STAFF REPORT: FEBRUARY 12, 2025, REGULAR MEETING **PREPARED BY:** T. BOSCARINO
APPLICATION NUMBER: HDC2025-00693
ADDRESS: 445 LEDYARD UNIT 6-7 (AKA 445 LEDYARD [MARINERS INN] AND 457 LEDYARD [JOHN H. AVERY HOUSE])
HISTORIC DISTRICT: CASS PARK LOCAL
APPLICANT: JR WATKINS, PEA GROUP
OWNER: MARINERS INN
DATE OF PROVISIONALLY COMPLETE APPLICATION: DECEMBER 2, 2024
DATE OF STAFF SITE VISIT: JANUARY 8, 2025

SCOPE: EXPAND PARKING LOT

Site plan from application documents. The “existing building” at the top is 445 Ledyard, the building at the bottom is 457 Ledyard. Note that the parcel boundary is not shown on the site plan; it approximately corresponds with the northern extent of the footprint of the building at 457 Ledyard.

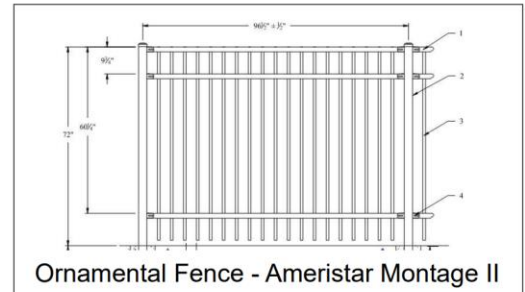
The primary scope item is the expansion of the current parking lot. The proposed work would move the curb cut a few feet to the east, repave the relatively small parking area beside 445 Ledyard, and expand the parking area to cover most of the rear yard of 457 Ledyard. To accommodate this additional paved area, the sheds would be removed.

- Staff suggests that the proposed, pole-mounted light fixtures, being of a simple and unobtrusive design, satisfy the “compatibility” required by Standard #9.
- The rationale for moving the curb cut is not provided; however, staff does not consider its location to be character-defining.

- The proposed change to the curb cut would remove a small section of sandstone curb, contrary to Standard #2: “The removal of historic materials ... shall be avoided.”

- *The section of sandstone curb that is removed will be retained and reused to infill the gap to the west of curb cut.*

Proposed light fixture and fence. Images from application documents.

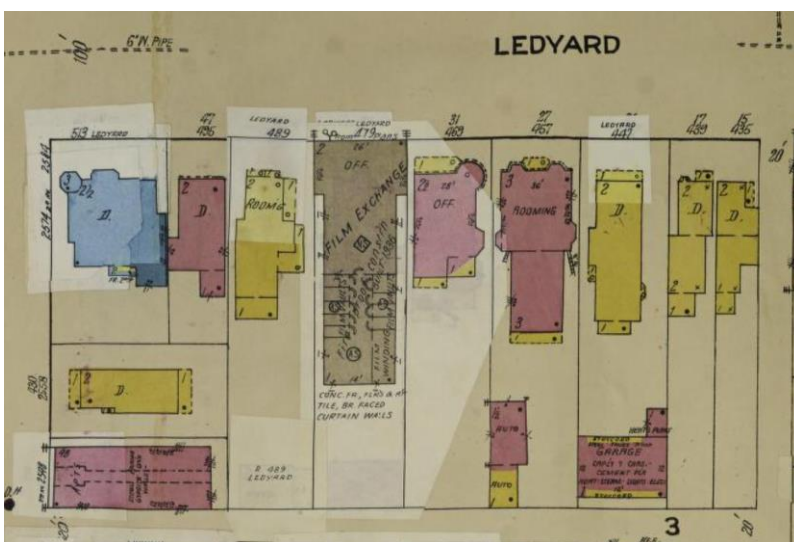
- The larger shed was installed without approval; its removal is acceptable as it would be reversing unapproved work.
 - A “mixed-use, urban, neighborhood of apartment, office, and institutional buildings” is noted in the Elements of Design as quoted above. Staff notes that this character existed during the period of significance. Staff opinion is that the proposed parking lot, fence, and lighting are consistent with the character of such an environment, satisfying Standard #9: “New additions, exterior alterations, or related new construction shall not destroy historic materials that characterize the property. The new work shall be differentiated from the old and shall be compatible with the massing, size, scale, and architectural features to protect the historic integrity of the property and its environment.” The proposed fence also meets the *Fence and Hedge Guidelines*.
